PLANNING COMMISSION REPORT
Regular Agenda – Public Hearing Item

PC Staff Report
5/24/2017

ITEM NO. 1A SPECIAL USE PERMIT FOR LMH; W. 3rd & MICHIGAN ST (SLD)

SUP-17-00153: Consider a Special Use Permit/Institutional Development Plan for a new parking lot at Lawrence Memorial Hospital and a master plan for the Hospital uses, located at W. 3rd & Michigan St. Submitted by Landplan Engineering for LMH Board of Trustees and City of Lawrence, property owners of record.

Figure 3: Lawrence Loop

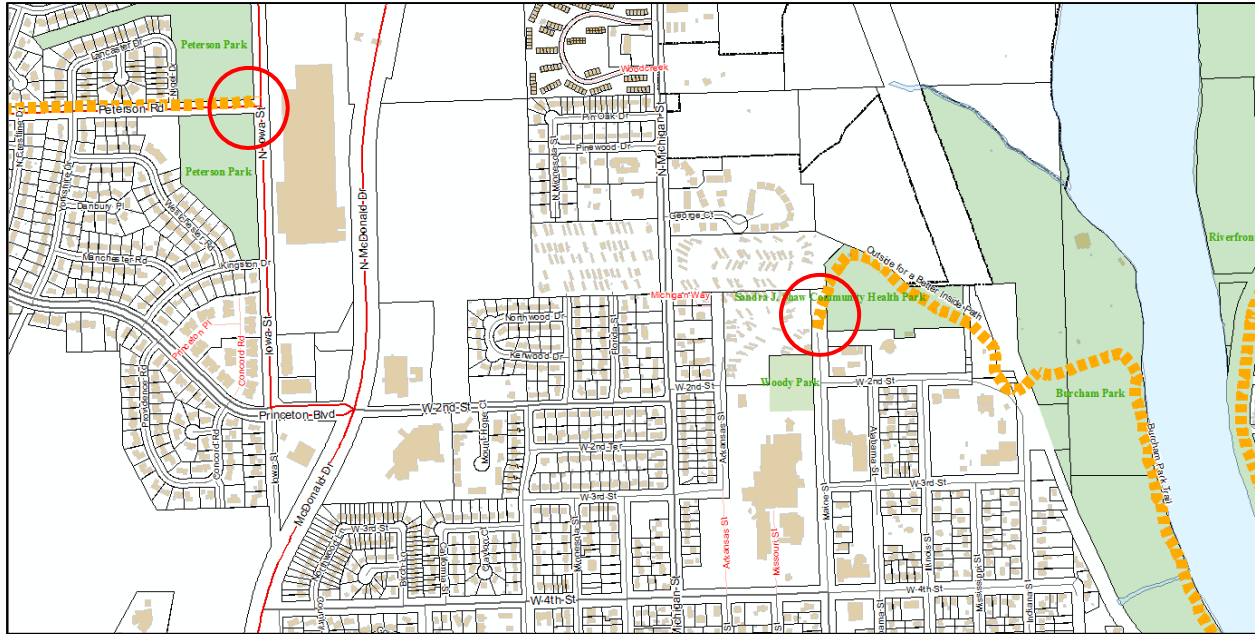
Connection of a shared-use path from Sandra Shaw trail through Woody Park or around the Hospital Property to 2nd and Michigan should be noted on plan. An agreement to fund and construct shared-use path adjacent to LMH should be included with proceeding with phase 2 to install the on-street parking spaces.

- g. Provision of a revised plan to show a conceptual 10' connection of a shared-use path from Sandra Shaw trail through Woody Park or around the Hospital Property to 2nd and Michigan with a note on the face of the site plan that the alignment may be modified by the pending MPO study.

Figure 7: Future Sidewalk along north access drive.

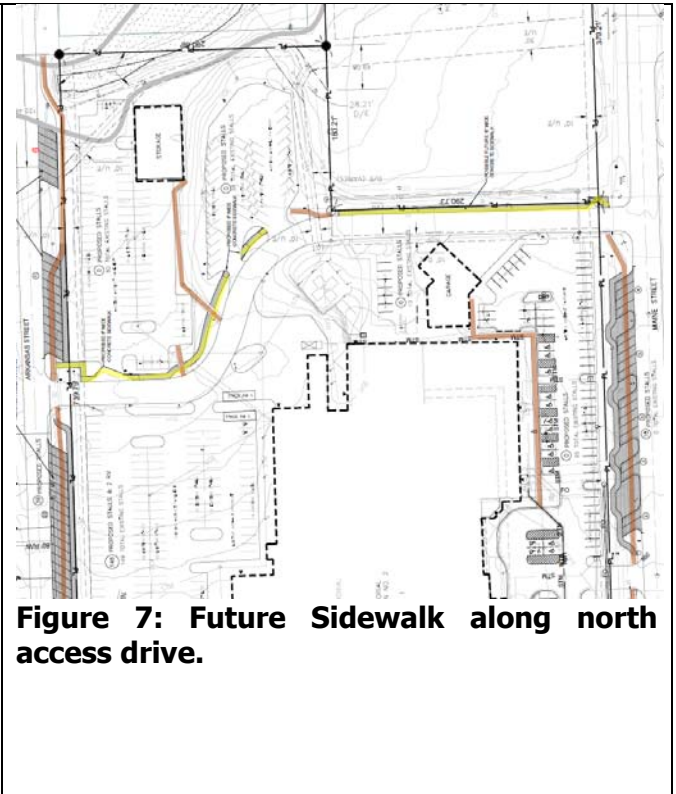
The plan shows a new sidewalk along the north side of the access drive in the north portion of the development shown in figure 8. The plan notes states "Possible Future 6' wide concerned sidewalk." The project does not commit to the construction. The existing access drive is 25' wide. The sidewalk would be located back of curb with no separation. The access drive is not a public street but is used for cut-through traffic and is blocked when the heliport is in use.

Figure 8: Recommended landscape along north and south property lines

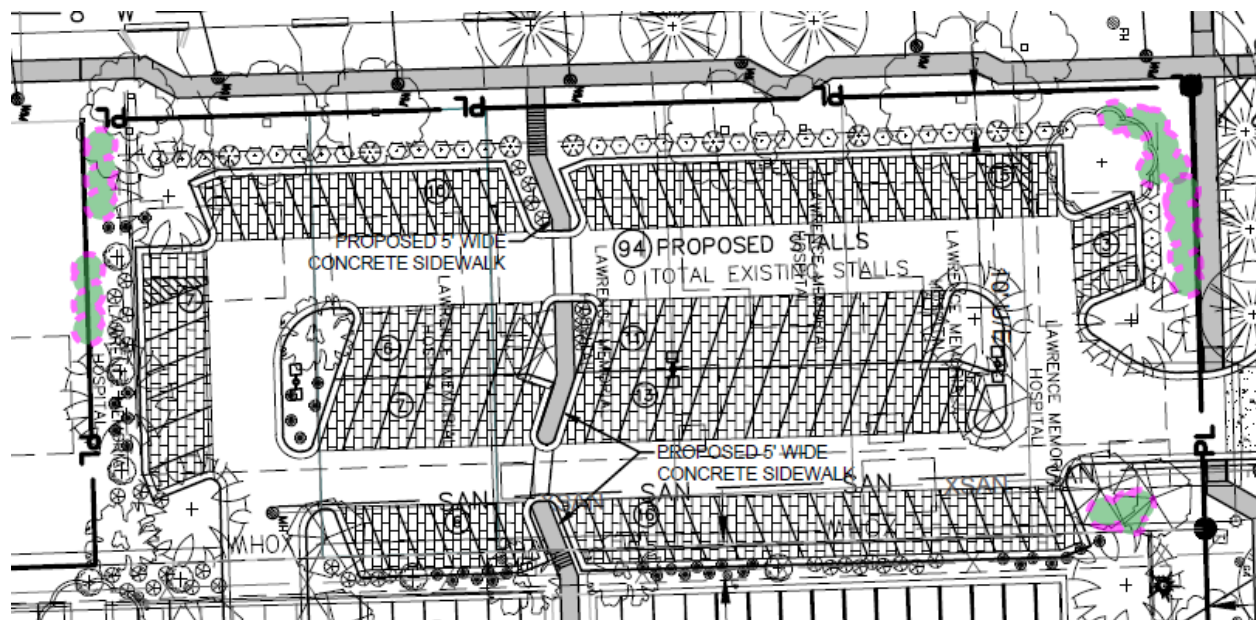
Bufferyard: A Type 3 Bufferyard is required along the H district that abuts an RS district. This standard applies to the parking lot expansion along the north and south sides of the project and along Michigan Street. The plan shows a 15' buffer yard with dense landscaping along the south side of the expanded parking lot. This section of the parking lot immediately abuts an existing residence. The plan shows an appropriate number of trees and shrubs along this buffer. A narrower buffer yard also requires a fence, wall or berm. The plan does not show the use of a fence, wall or berm in this location. The site will be filled to raise the level of the parking lot to better match and tie into the existing parking lot. Staff recommends the applicant add additional vegetation to increase the screening of the parking lot from the residence rather than install a fence or wall.

W. 3rd Street requires: 4 street trees for 125' of frontage; 2 trees for perimeter landscaping; 8 trees as a Type 3 Buffer Yard. These numbers are not cumulative. Street trees may be counted toward the required perimeter and buffer yard requirements. This street segment also includes a new driveway that restricts area available for planting. Landscape along W. 3rd Street is layered with three street trees shown along the right-of-way and 4 trees located within the north section of the parking lot. In addition to trees, a buffer yard must be planted with shrubs. Along W. 3rd Street 19 shrubs are required. The plan shows only 5 shrubs. The minimum width of the buffer yard also should include a fence, wall or berm. None is proposed with this application. Additional landscape is recommended to offset the requirement.

- c. Revise the landscape plan to include additional shrubs along the north and south property lines to screen the parking lot from adjacent residence.

Figure 9: Recommended additional landscape along Michigan Street.

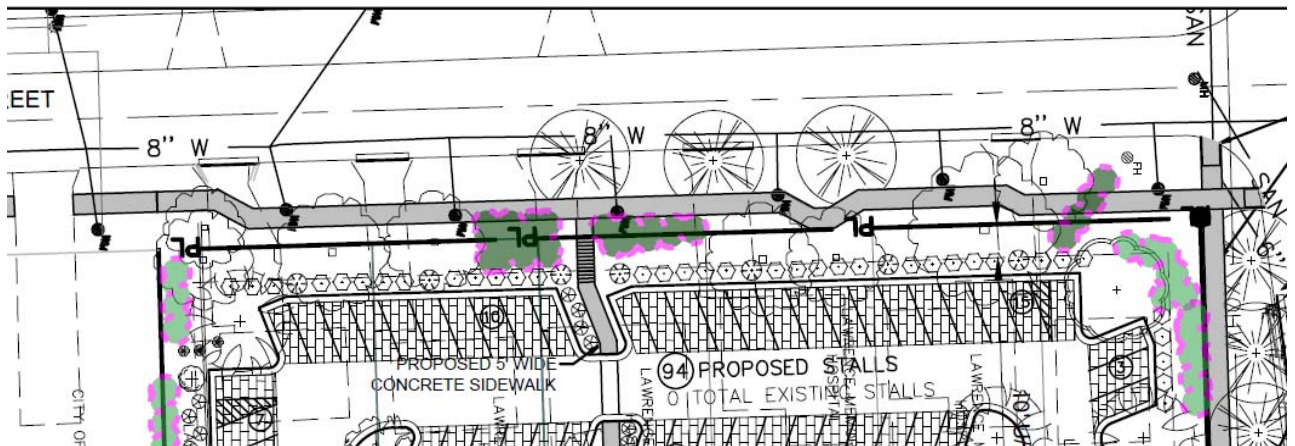
The plan shows 232' of parking along Michigan Street at one tree per 25', 9 trees would be required. A total of 8 trees are required along Michigan Street to meet this standard. Additionally, a Type 3 Bufferyard, 15' wide, as proposed along Michigan Street requires 13 trees and 47 shrubs. The plan complies with the minimum street trees standard and the perimeter parking lot standard but does not comply with the buffer yard standard. Staff recommends the addition of ornamental trees and additional shrubs along Michigan Street.

- d. Revise landscape plan to include additional shrubs and ornamental trees along Michigan Street.
 - e. Provision of a note that states Public Improvements Plan are required for review and approval for the following improvements:
